Re: Response to 4th Technical Notice of Deficiency Letter Dated April 11, 2019
Permit Renewal/Compliance Plan with Major Amendment
Union Pacific Railroad Company – Houston Wood Preserving Works, Houston, Harris County, Texas
Hazardous Waste Permit/Compliance Plan No.: 50343, ISWR No. 31547
Tracking No. 18836453; CN600131098/RN100674613

Application Deficiencies - Technical NOD #4

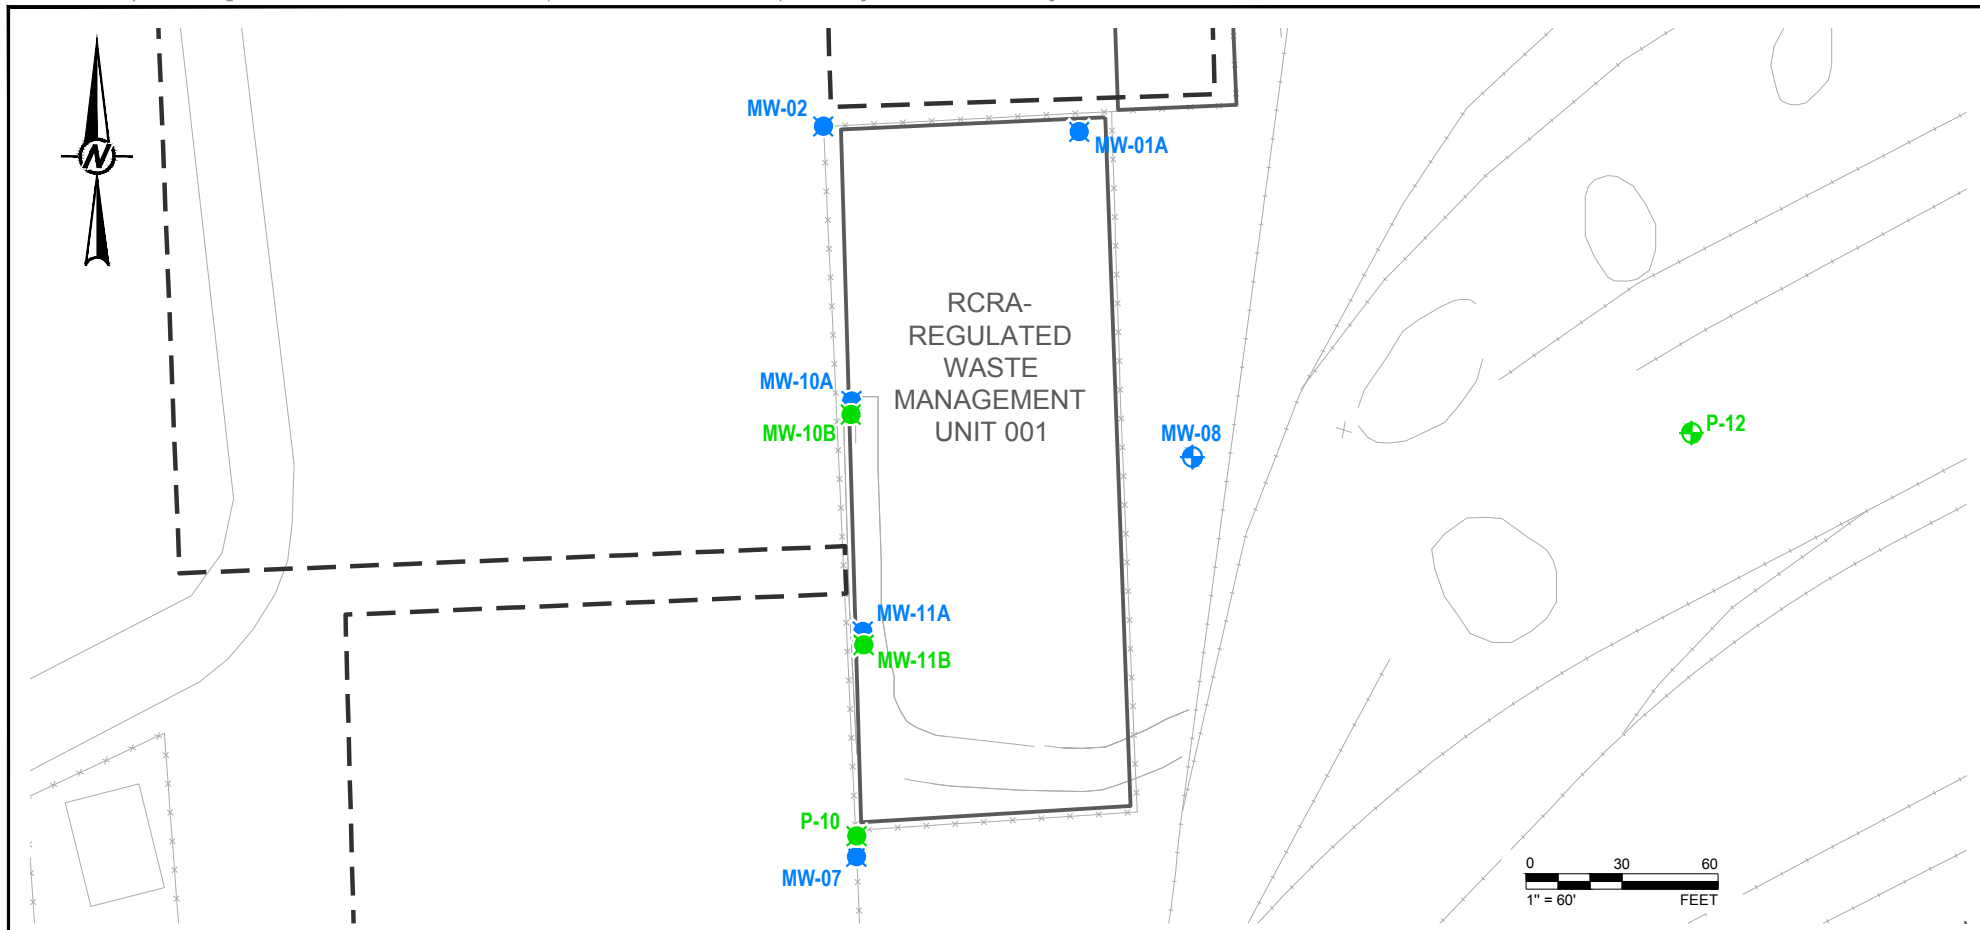
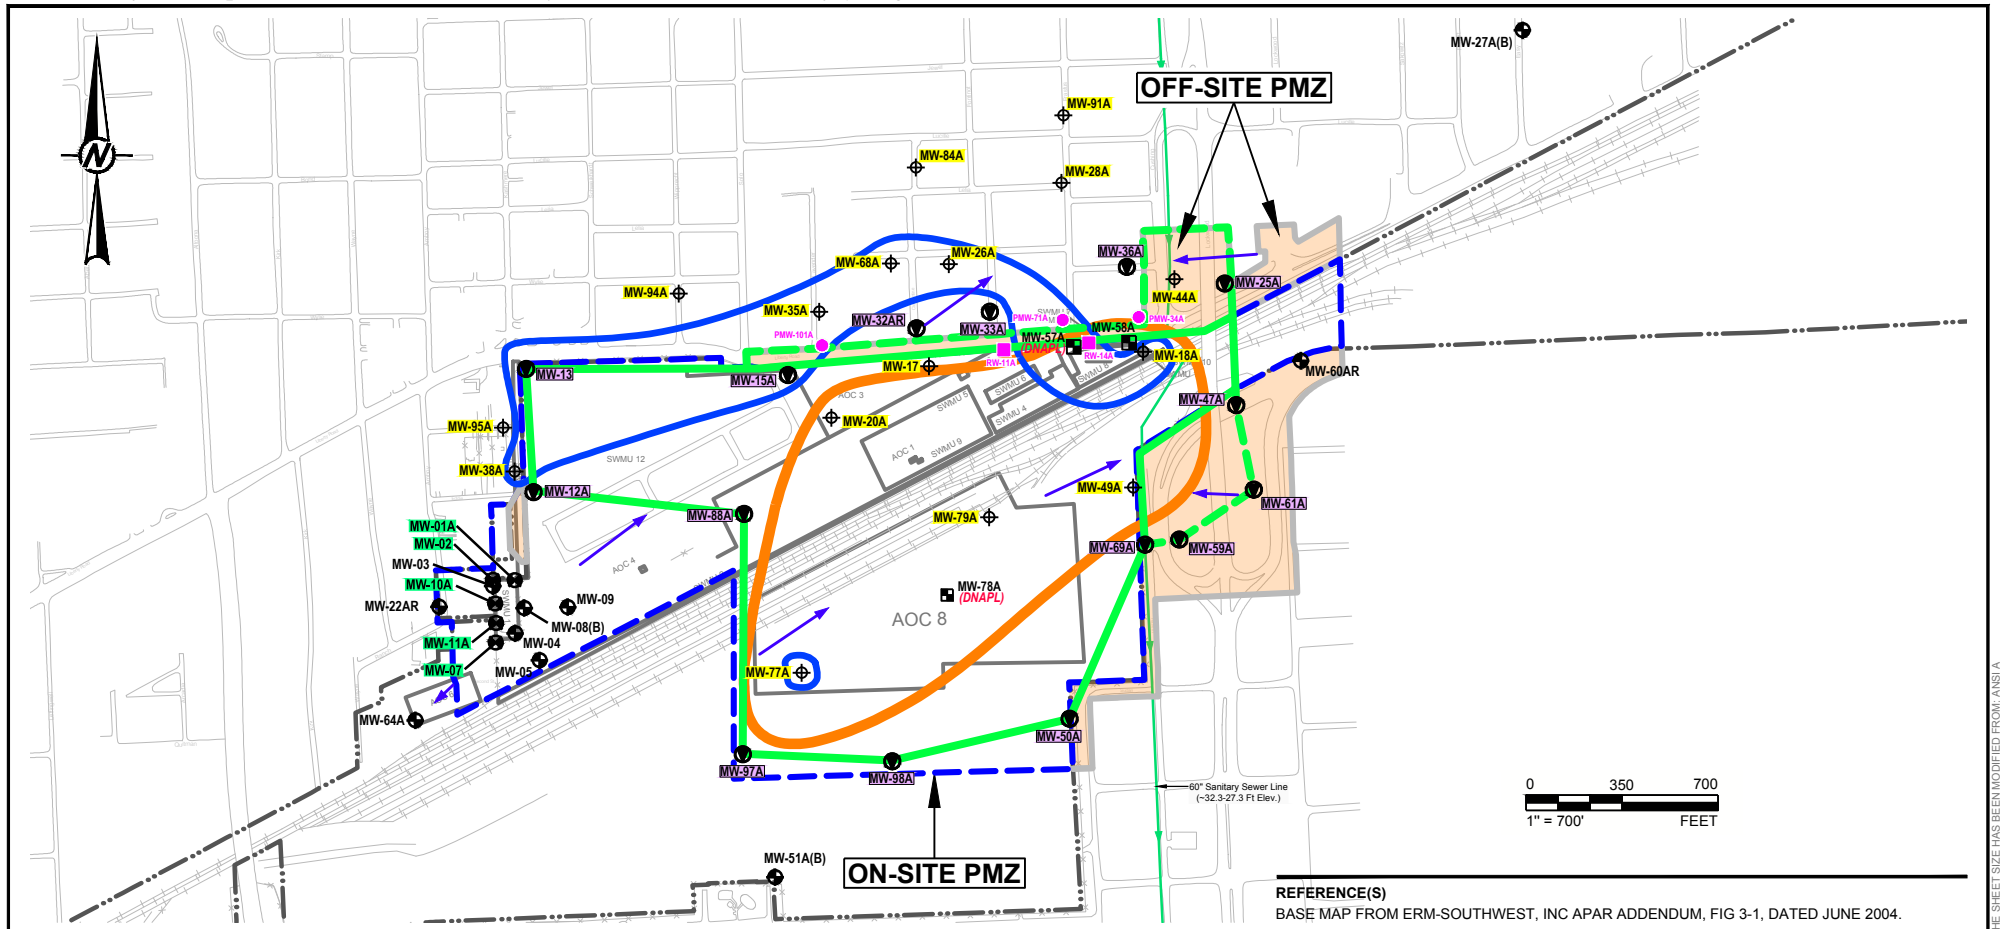
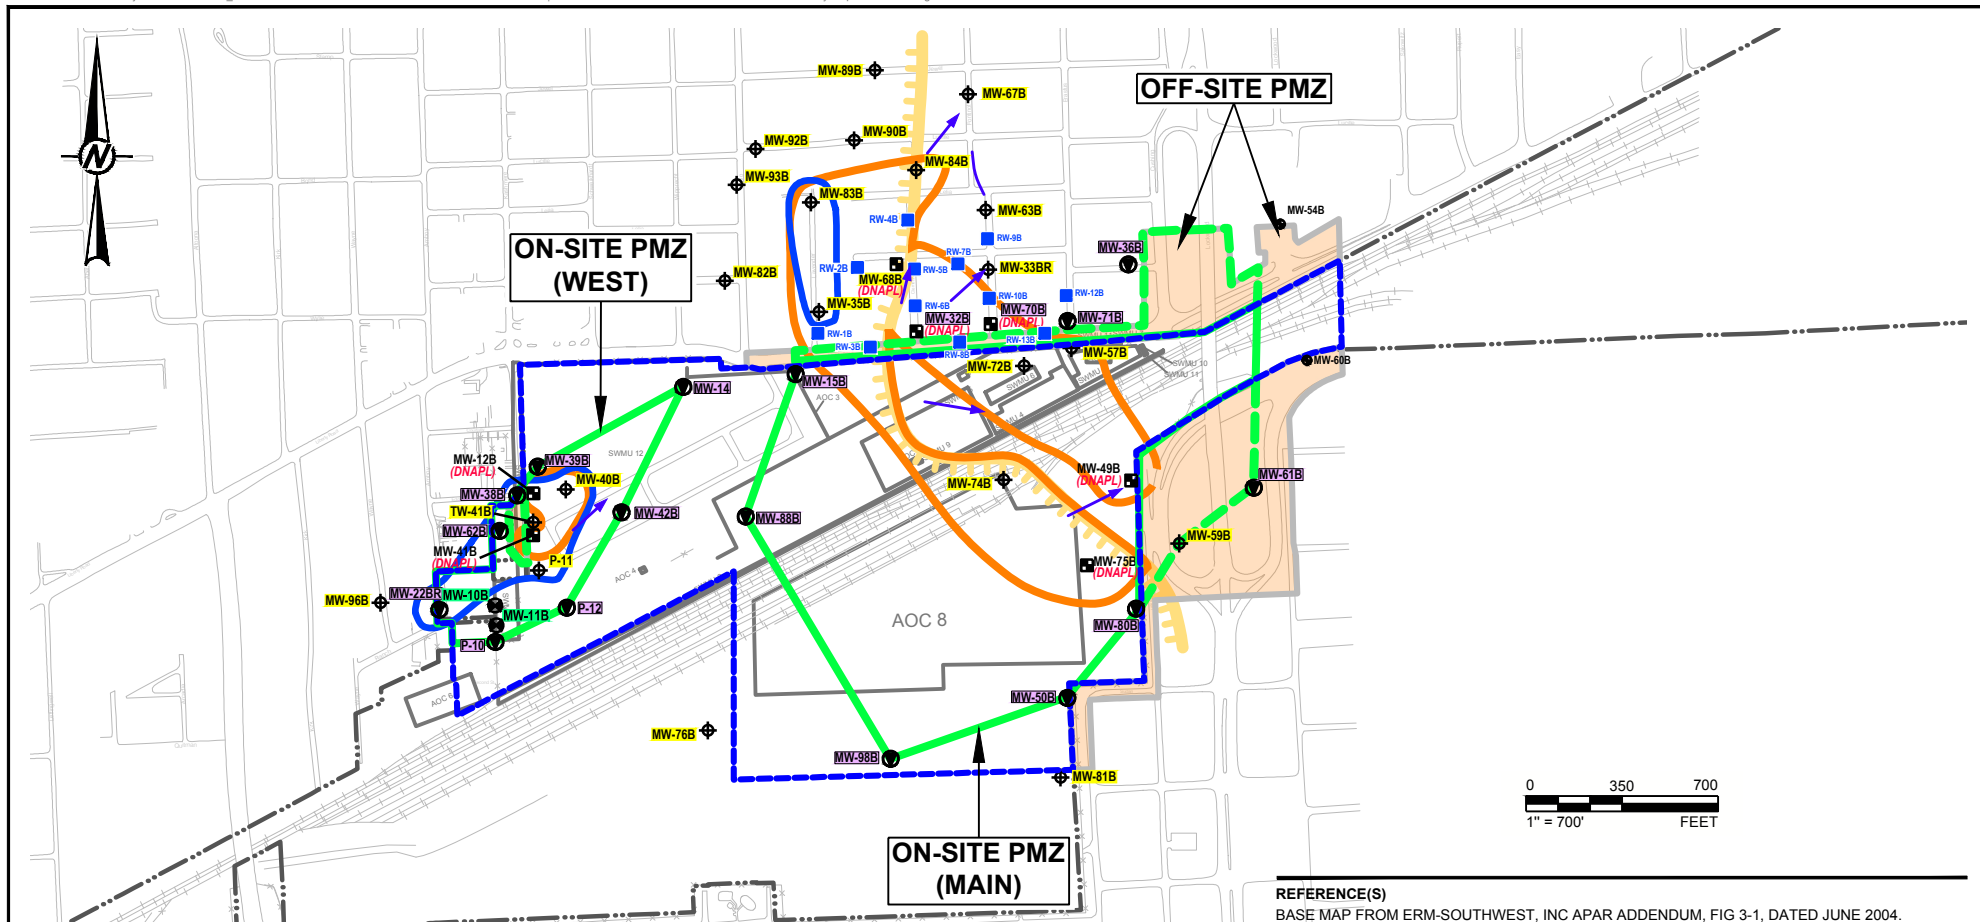
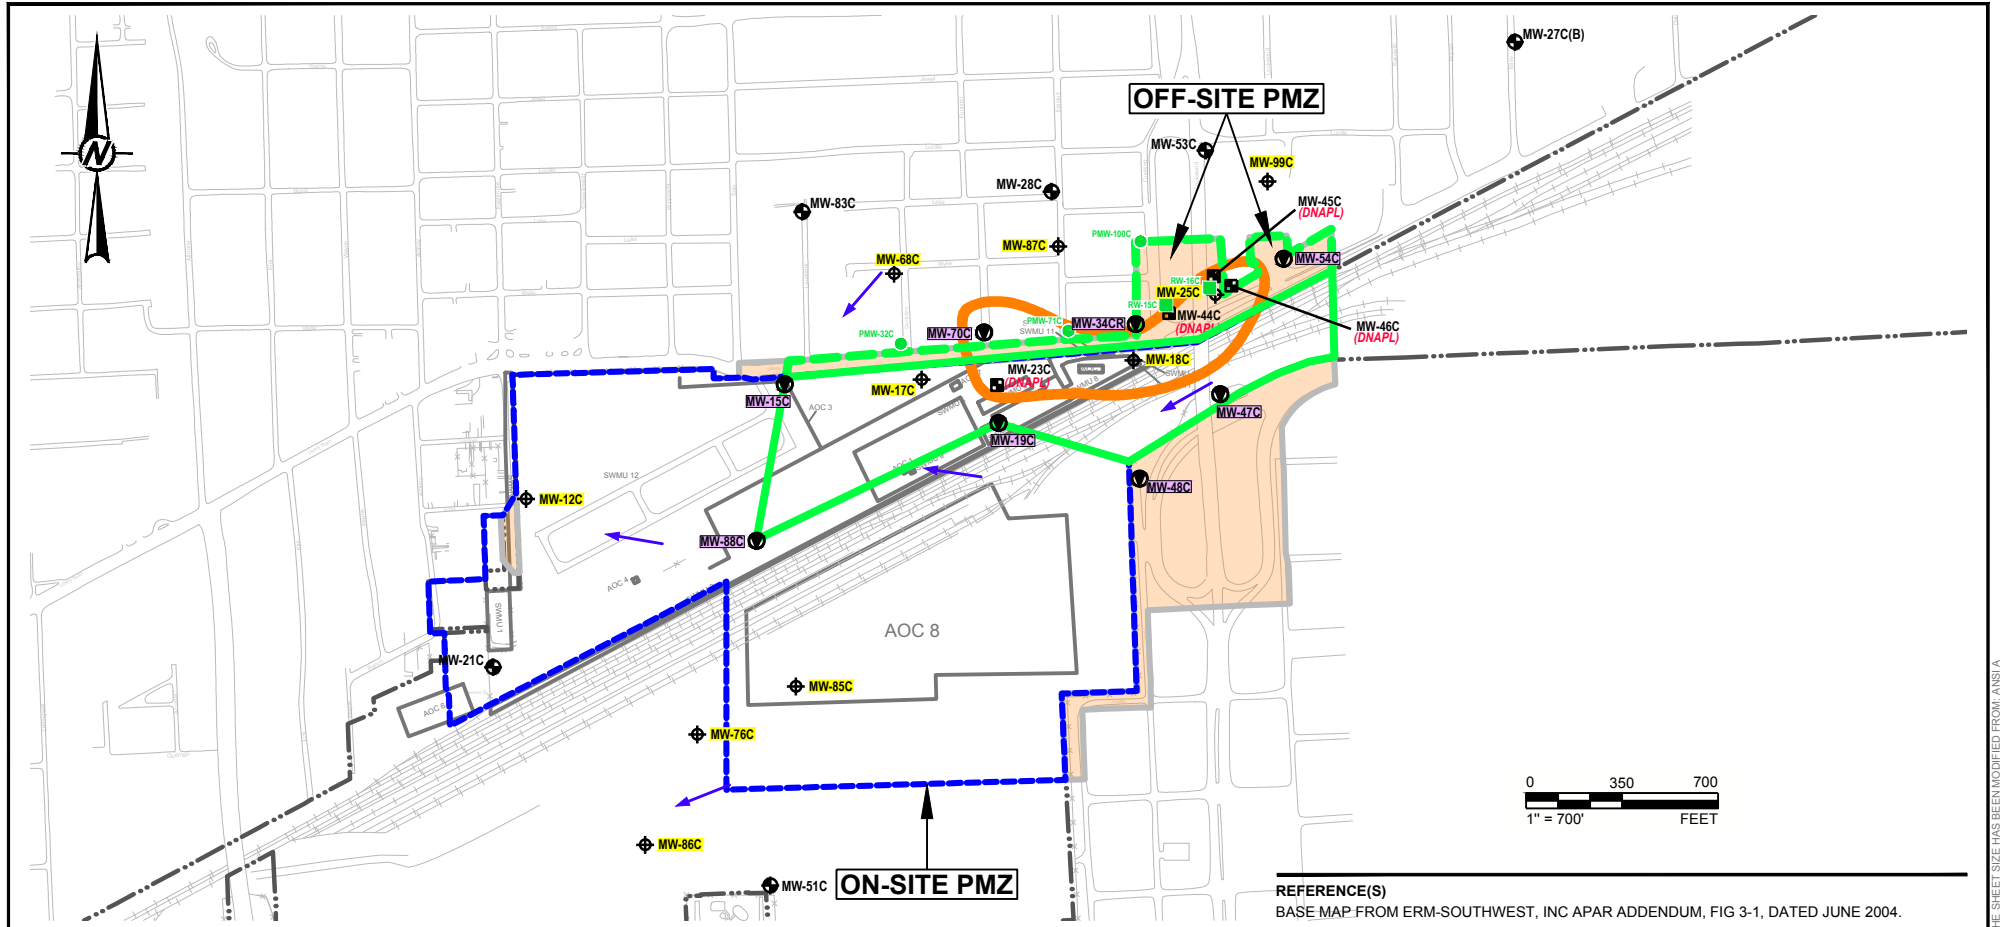
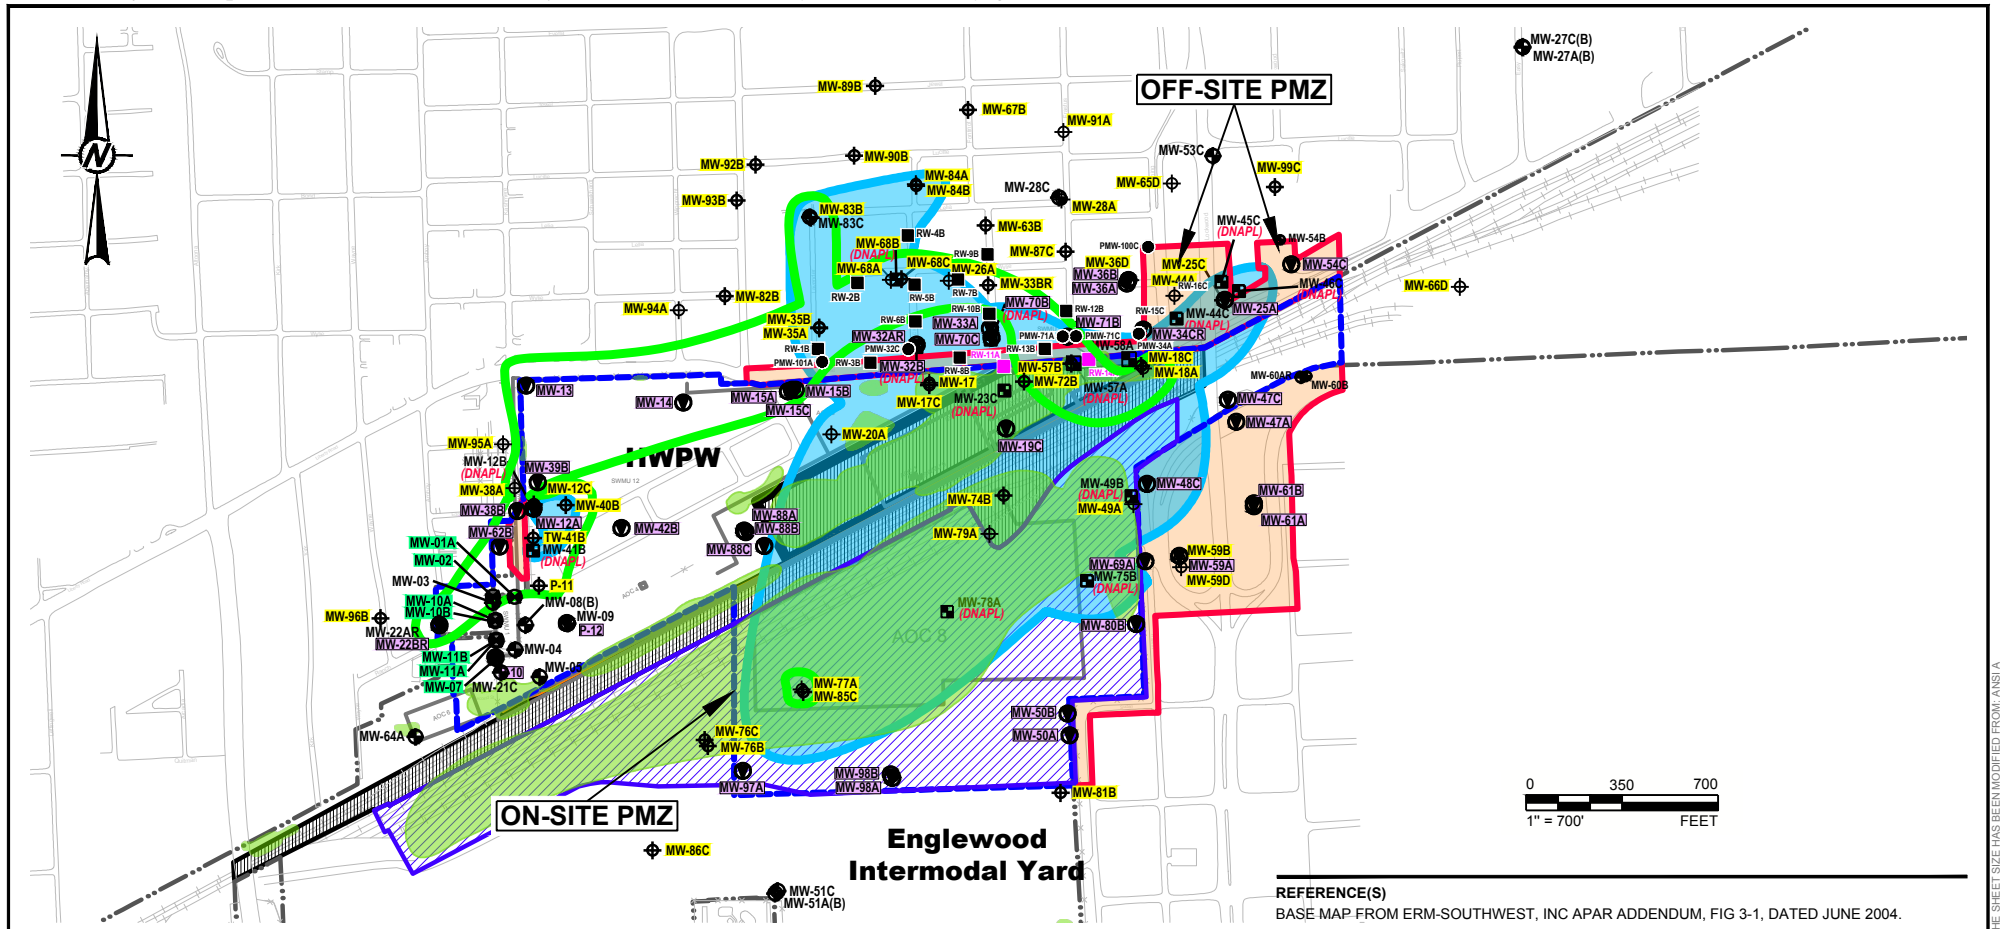
Specific T23(3)	B	XI.A.	XI.A.1, XI.A.2, & XI.A.3	30 TAC 335.167 & 350	Inconsistent / Incomplete	<p>Since the proposed PMZ shall be limited to the on-site UPRR owned property, revise the CP Attachment A Figures to include the following:</p> <ul style="list-style-type: none"> CP Attachment A, Sheet 1 of 7, "Facility Site Map" is not legible. Provide a new map that clearly labels the facility name, facility property boundary, and nearby local roadway (e.g. interstate, highway, etc..) with respect to the City of Houston. CP Attachment A, Sheet 2 of 7, Solid Waste Management Units (SWMUs)/ Areas of Concern (AOC) Location Map. Revise this figure and legend by deleting all references to proposed on-site and off-site TI Zones, and the off-site PMZ boundary. The PMZ boundary should be limited to only the UPRR property. Also, the text in the legend and name of the specific SWMUs/AOCs is not legible. CP Attachment 3 of 7, Compliance Monitoring Well Network. The point-of compliance (POC) wells and background wells should have different symbols so the wells are easily distinguished from one another. Also, the name of the RCRA Permitted Unit which is identified as "SWUM 1" needs to remain as "RCRA-Regulated Waste Management Unit 001" to be consistent with the facility Notice of Registration (NOR). CP Attachment A, Sheet 4 of 7, PMZ Boundary Map, A-TZ. Remove all references to the off-site PMZ and TI. The title should be re-labeled to state, "PMZ Boundary and Well Location Map, A-TZ." Remove references to AMP wells in the figure. Revise the figure to reflect the following list of wells as designated below: <u>On-site Main PMZ:</u> <ul style="list-style-type: none"> Alternate point of exposure (APOE) wells: MW-15A, MW-17, MW-18A, MW-49A, MW-50A, MW-57A, MW-58A, MW-60A, MW-69A. Corrective Action Observation (CAO) wells: MW-18A, MW-20A, MW-51A, MW-77A, MW-78A, MW-79A. <u>On-site West PMZ:</u> <ul style="list-style-type: none"> APOE wells: MW-38A. CAO wells: MW-9, MW-12A, MW-13. <u>Off-site CAO wells:</u> MW-25A, MW-26A, MW-32AR, MW-33A, MW-35A, MW-36A, MW-44A, MW-59A, MW-61A. <u>Background well:</u> MW-51A. <u>Corrective Action System wells:</u> MW-17A, MW-18A, MW-20A, and MW-79A. CP Attachment A, Sheet 5 of 7, PMZ Boundary Map, B-CZ/B-TZ. Remove all references to the off-site PMZ and TI. The title should be re-labeled to state, "PMZ Boundary and Well Location Map, B-CZ/B-TZ." Remove references to AMP wells in the figure. Revise the figure to reflect the following list of wells as designated below: <u>On-site Main PMZ:</u> <ul style="list-style-type: none"> APOE wells: MW-15B, MW-47B, MW-49B, MW-57B, MW-72B, MW-80B, MW-81B. 	<p>UPRR revised the Compliance Plan (CP) Attachment A figures to reflect the proposed response actions detailed in the Revised RAP. As a result, some of the well designations suggested by the TCEQ are not applicable for the proposed response action. Please see Worksheet 2.1 in the Revised RAP and CP Attachment A for the proposed well designations. UPRR removed all references to proposed TI zones and off-site PMZ except for the proposed off-site PMZ within the City of Houston ROW.</p>

ID ¹	App. Part	App. Section	Location ²	Citation	Error Type ³	Deficiency Description/Resolution	Response
						<p>o CAO wells: MW-14, MW-74B, MW-75B. <u>On-site West PMZ:</u> o APOE wells: MW-38B, MW-39B, MW-42B, MW-62B. o CAO wells: MW-12B, MW-40B. <u>Off-site CAO wells:</u> PMW-28BA, MW-26A, MW-32B, MW-33BR, MW-35B, MW-36B, MW-44A, MW-59B, MW-63B, MW-67B MW-68B, MW-70B, MW-71B, MW-82B, MW-83B, MW-84B, MW-89B, MW-90B <u>Corrective Action System wells:</u> MW-57B, MW-68B, MW-72B, and MW-74B.</p> <ul style="list-style-type: none"> CP Attachment A, Sheet 6 of 7, PMZ Boundary Map, C-TZ. Remove all references to the off-site PMZ and TI. The title should be re-labeled to state, "PMZ Boundary and Well Location Map, C-TZ." Remove references to AMP wells in the figure. Revise the figure to reflect the following list of wells as designated below: <u>On-site Main PMZ:</u> o APOE wells: MW-15C, MW-17C, MW-18C, MW-47C, MW-48C, o CAO wells: MW-19C, MW-23C, MW-45C, MW-51C, MW-76C, MW-75B. <u>On-site West PMZ:</u> o APOE wells: MW-12C <u>Off-site CAO wells:</u> MW-25C, MW-27C, MW-34CR, MW-44C, MW-45C, MW-46C, and MW-54C MW-68C, MW-83C, MW-87C, <u>Corrective Action System wells:</u> MW-17C, and MW-18C CP Attachment A, Sheet 7 of 7, Post-Response Action Care Well Location Map. Remove all references to off-site PMZ and TI. The title should be re-labeled to state, "Well Location Map, D-TZ" because the TCEQ shall require UPRR to continue monitoring the deeper transmissive zone to verify the groundwater PCLE zone is not migrating vertically. Include D-TZ wells MW-36D, MW-59D MW-65D and MW-66 D as CAO wells. <p>Since all the above CP Attachment A figures will be included in the Final Draft Permit (FDP) as a black and white copies, each well designation (i.e., APOE, background well, CAO well, etc.) should have a separate symbol that is easily distinguished. The font may need to be enlarged and/or darkened on all the maps.</p> <p>For future reference, please note that CAO wells, CAS wells, and any future AMP wells should not be listed in CP Tables. These wells are only depicted in the CP Attachment A maps so that once wells meet their respective PCLs, UPRR may propose to discontinue monitoring for those wells in future Groundwater Monitoring Report submittals to account for changing environmental conditions and/or plume morphology without modification to the Permit.</p>
